**STAFF REPORT:** FEBRUARY 07, 2024, REGULAR MEETING

**APPLICATION NUMBER:** HDC2024-00025

**ADDRESS:** 1942 GRAND RIVER

**SCOPE:** INSTALL WALL SIGNS AND AWNINGS

Proposed signs, left to right: 18’x3.5’ sign on Grand River (southwest) façade; 10’x2’ sign on Adams (northwest) façade; 10’x1.5’ sign at east corner entrance. Note that the Grand River sign projects forward on an aluminum awning.

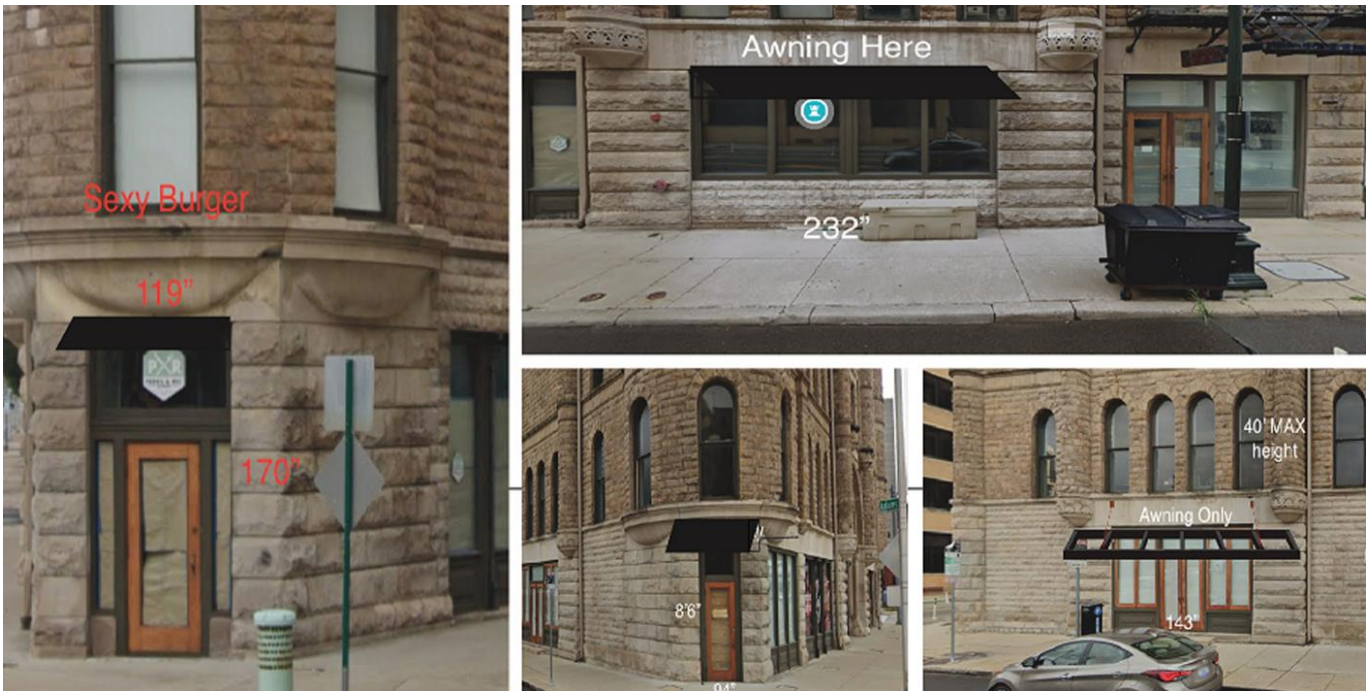
- A lack of dimensioned drawings make it unclear if the proposed Grand River (southwest façade) sign will be wider than the opening to which it is affixed. The renderings provided (see page 2, above) make it appear that the lettering will overlap the decorative stone surround.

- The proposed Adams (northwest) and east corner entrance signs are consistent with the *Sign and Awning Guidelines* and placed in a location that does not cover, distract from, or damage architectural features).

- The primary (southwest-facing, Grand River) entrance to the building is, in staff opinion, extremely important to the building's character. Adding a projecting, flat awning adds an overwhelming horizontal emphasis that is out of place in an opening that is otherwise defined by its vertical character. Further, the historic character of the opening is recessed, while the proposed awning and sign would project forward (the degree of projection is not known as a section drawing is not provided in the application materials). Finally, the size of the proposed sign is too large in that it would overlap iron muntins within the opening and stone details surrounding the opening. Together, these issues result in an "alteration ... of spaces that characterize a property," contrary to Standard #2 of the Secretary of the Interior's Standards for Rehabilitation.<sup>2</sup>

- The proposed sign on the Grand River façade will be reduced in area, the proposed awning on the Grand River façade will be reduced in depth or eliminated altogether; these will be placed to avoid obscuring any architectural details, subject to review by staff.
- The awnings will be set entirely within the existing door and window openings, rather than overlap onto the building's stone façade, subject to review by staff.

Four additional proposed awnings, clockwise from left: east corner entrance, Cass (northeast) façade, Adams (northwest) façade, west corner entrance. Image from application documents.

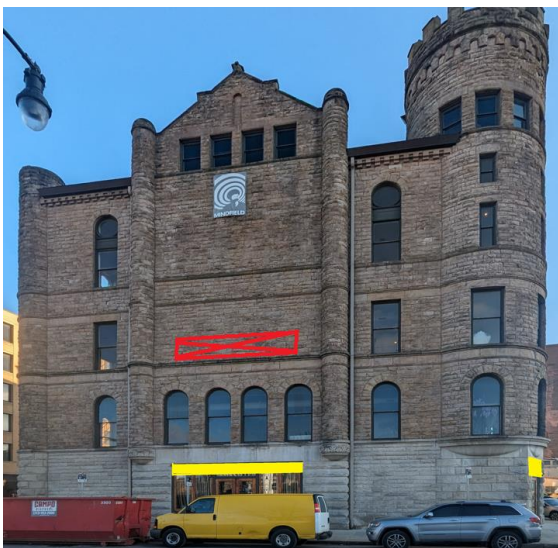
- The application does not provide enough information to evaluate the appropriateness of the four proposed awnings (staff has requested additional information). The renderings suggest that the awnings may overlap onto the surrounding stone façade. It is also not clear how the awnings are to be mounted. Obscuring any part of the stonework surrounding the openings would be contrary to Standard #2 and the guidance of *Preservation Brief 44* as quoted above. Damaging any part of the stonework, such as by fastening to stone, rather than mortar joints, would be contrary to Standard #9: "exterior alterations, or related new construction shall not destroy historic materials that characterize the property."<sup>3</sup>
